January 6, 2009

**Re: Response to comments received on review of request to amend NWB water use licence 2BE-KIG0812 to allow drilling within 30 metres of a high water mark at the End Grid location**

Figure 1

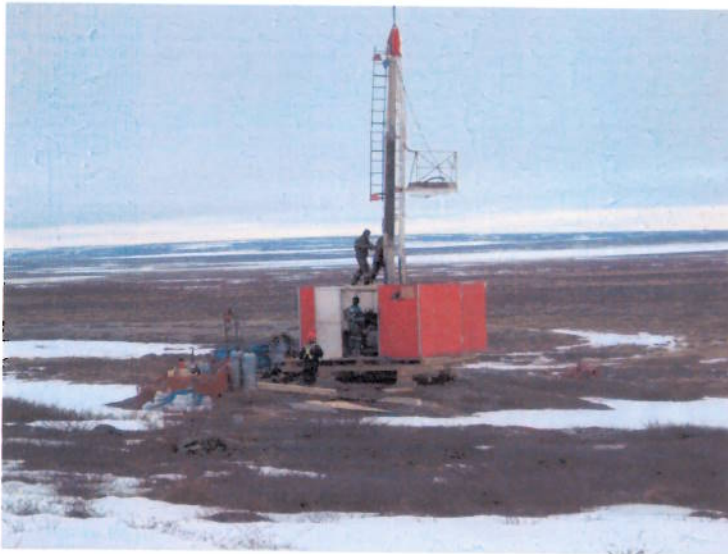
*One of the main reasons for the 30 m prohibition is to protect the near shore areas of water bodies. To this end, any work that occurs in that area must be done such that there is no disturbance to surficial materials or permafrost, so that surface erosion does not occur. The proponent has not provided details of mitigation measures for protecting surface stability. EC requests that this information be provided for review prior to approval of this amendment request. Our concerns lie with the setup of the drilling rig on the organic materials, and with traffic across the small streams. In addition to the potential for surface disturbance, there is the potential for thermal erosion if ice lenses are exposed and subsequently thaw;*

ARC has worked diligently at establishing mitigation measures from the how the drill is set up, to improving drilling activities and implementing actions to prevent materials from entering water bodies. In addition to limiting time spent drilling at each site to the greatest extent possible, drill rigs are set-up on 6x6 beams which raise the actual platform approximately 2-3 feet above the tundra surface (Refer to Figure 1). This allows for the continual air movement through the base, preventing heat from being transmitted from the equipment into the tundra. In the 30 years that

this method of set-up has been practiced in the area, ARC's geologists have not observed thermal erosion.
